SERVICE BULLETIN

Number: SB0505

Subject: Deck Tensioner on 52K23X

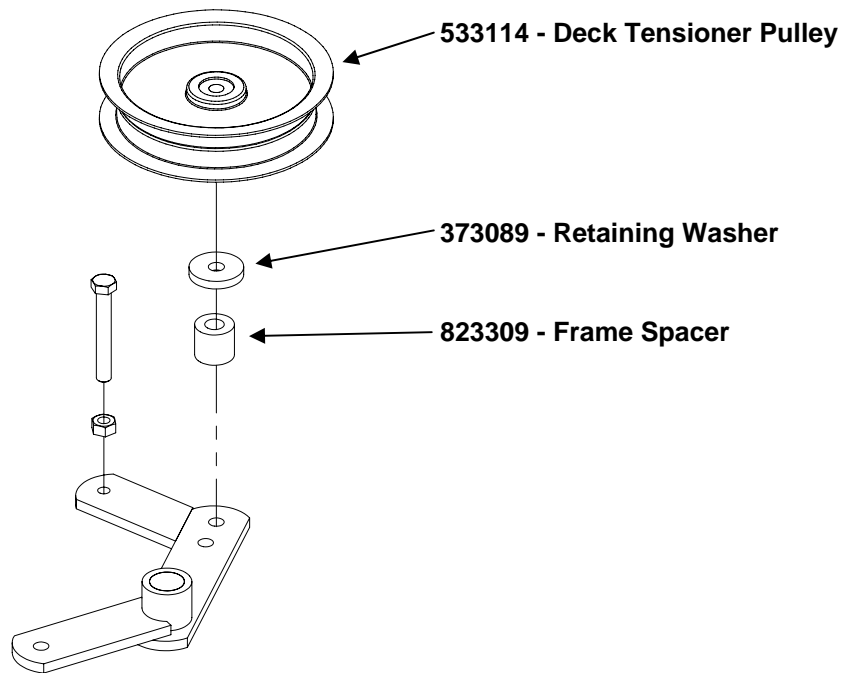
Details: Encore 52K23X units with serial # 51622 and above now have a different tensioner pulley installed on the deck assembly. Please make note of the new tensioner assembly and part # changes as shown in the diagram below.

Please make note of these new parts and part numbers in your 52K23X illustrated parts manual.
